SUBJECT: WESTINGHOUSE RESPONSES TO NRC REQUESTS FOR ADDITIONAL
INFORMATION ON THE AP600

Enclosed Responses to NRC Requests for Additional Information

Enclosure 2 to Westinghouse Letter NTD-NRC-95-4594

NRC REQUEST FOR ADDITIONAL INFORMATION

Figure 440.437-1 Steam/Water Supply tank (Prepurifier)

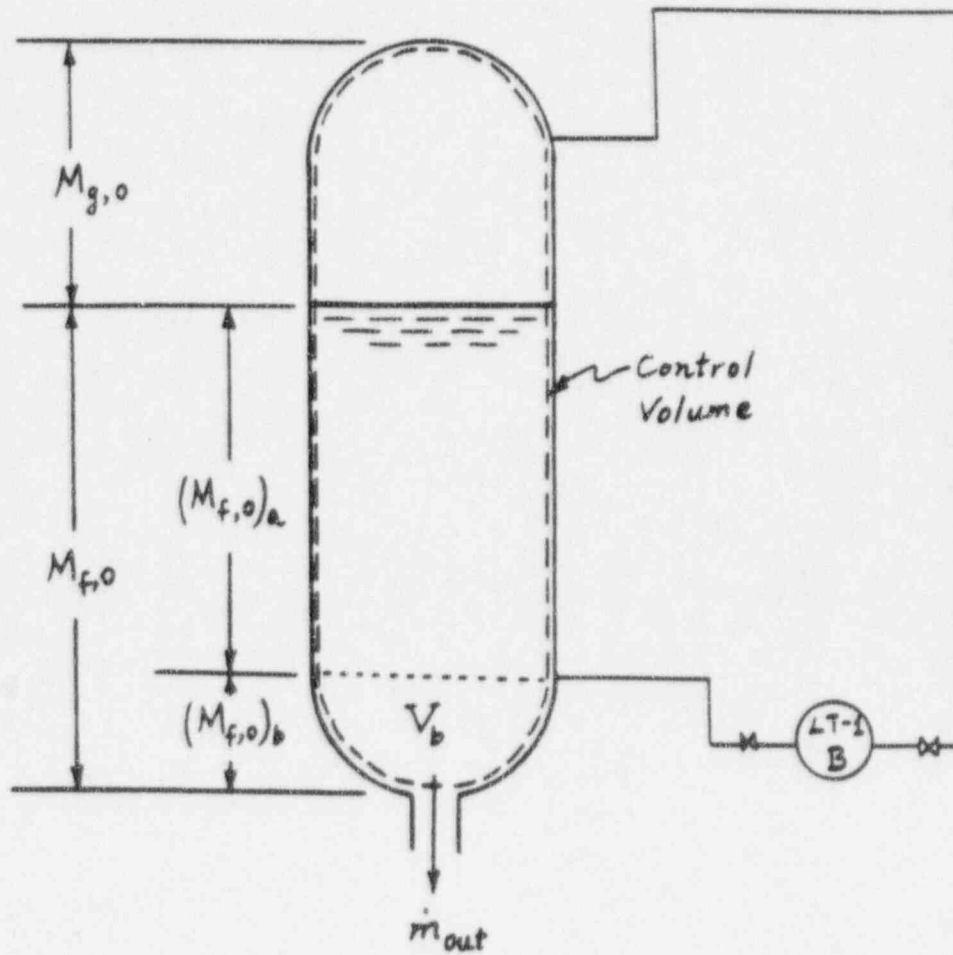
NOTRUMP overpredicts the depressurization rate in the pressurizer for several tests while the fluid qualities in the ADS lines for these tests were underpredicted. Since lower quality should lead to a reduced depressurization rate, please explain this inconsistency. See for example Figs. 4-13, and 4-33, 4-53. Also, these tests are only displayed for 30 seconds and only capture the very initial short period of the depressurization. Please explain why the comparisons were not carried out beyond 30 seconds or until atmospheric pressures are approached. Some of the tests show a marked deviation between the data and the NOTRUMP prediction suggesting the long term depressurization may be grossly overpredicted as in Figs. 4-53, while the flows show a growing discrepancy with the data as in Figs. 4-32 and 4-12 at 30 seconds. Since the ultimate judge of the ADS is its ability to depressurize the system to very low pressure, displaying the test comparisons for only the first 30 seconds where the system remains at elevated pressures does not demonstrate the NOTRUMP code ability to predict ADS depressurization over the full range of system pressures. Please provide the NOTRUMP comparisons to the data until the system has completely depressurized.

To show that the depressurization of the pressurizer depends only on the flow rate but not on the fluid quality, consider the control volume enclosing the pressurizer volume as shown in Figure 440.437-1. The conservations of mass, energy, and pressurizer volume are:

the depressurization rate. Since NOTRUMP overpredicts the flow rate, it also overpredicts the depressurization rate, which is correct no matter what flow quality downstream is predicted.
